Isolation Proposals, Revised 2025-03-13

Submitted by Jason Potterf - Cisco

Figure J-1 Isolated MPoE System Diagram

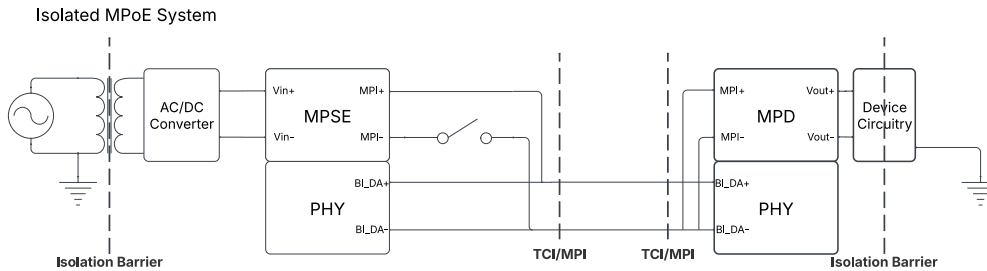
MPoE permits two approaches to electrical distribution system compatibility.

Isolated MPoE systems, as shown in Figure J-1, are recommended for mixing segments that cross any of the following:

- Ground references
- Boundaries between separate power distribution systems
- Boundaries of a single building

Isolated MPoE systems have isolation requirements that are aligned with Clause 33 and Clause 145 isolation requirements. These isolation requirements target compatibility with low-voltage systems that prohibit intentional grounding of any conductor, such as a Safety Extra-Low Voltage (SELV) system. Because the MPSE outputs are isolated and floating, disconnecting the more negative conductor is sufficient to stop the flow of power and ground loops are not present.

Figure J-2 Grounded MPoE System Diagram

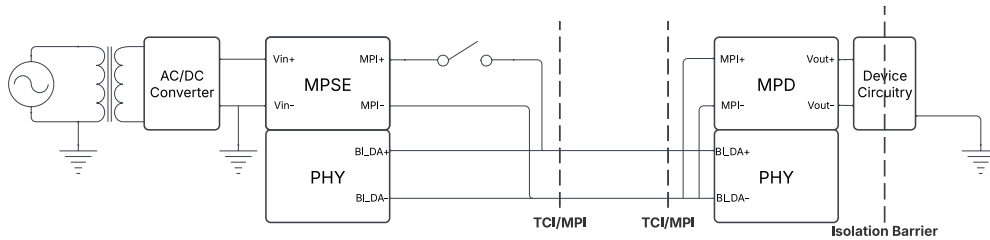
Grounded MPoE systems, as shown in Figure J-2, are recommended for mixing segments which, with all associated interconnected equipment, share a common, continuous ground.

Grounded MPoE systems have isolation requirements that are aligned with Clause 104 isolation requirements. These isolation requirements target compatibility with low-voltage systems that intentionally ground one conductor, such as a Protective Extra-Low Voltage (PELV) systems. Grounded MPSEs are permitted to ground the more negative conductor of their power supply, but are specified below to switch their more positive conductor to ensure that a ground path does not circumvent the MPSE's ability to stop the flow of power. MPDs are specified to meet a lower isolation requirement to ensure the current supplied by the MPSE on the MPI returns to the MPSE via the MPI.
